NEW BUSINESS: CODE AMENDMENT INITIATION REVIEW SHEET

Amendment: **Lake Austin Code Clean-Up** – Initiate an amendment to Title 25 of the City Code to clarify portions of the code related to Lake Austin development and remove conflicts and unintended consequences resulting from the 2014 Lake Austin code amendments.

LAKE AUSTIN CODE CLEAN-UP

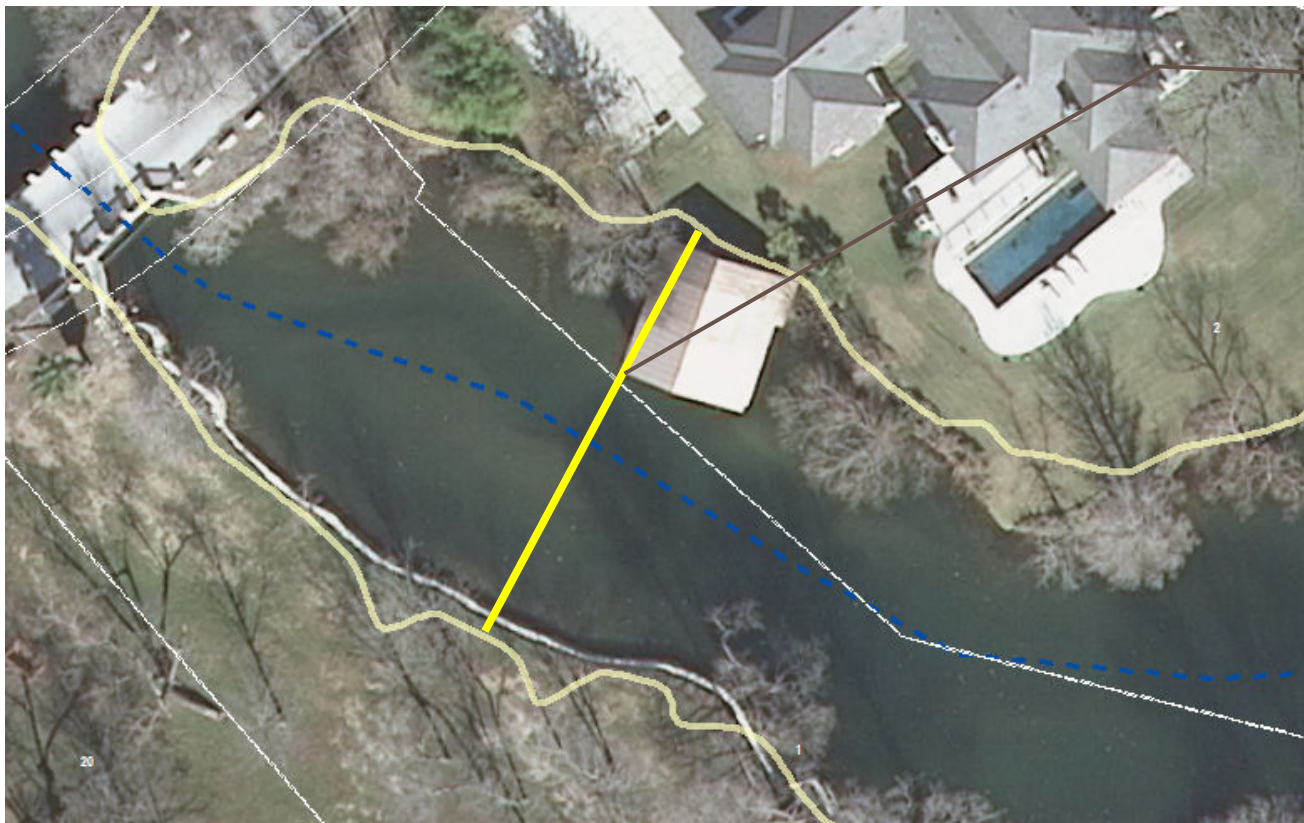
TYPOS

- ▶ § 25-2-55 I (C) (3) For a lot included in a subdivision plat recorded before April 22, 1982, or a tract that is not required to be platted, impervious cover may not exceed:
 - (a) 35 percent, on a slope with a gradient of 15 percent or less;
 - (b) 10 percent, on a slope with a gradient of more than 15 percent and not more than ~~25~~35 percent;
 - (c) 5 percent, on a slope with a gradient of more than 25 percent and not more than 35 percent; or
 - (d) 40 percent, if impervious cover is transferred under Subsection (D).

- ▶ Two § 25-2-55 I (E) sections – (~~E~~F)
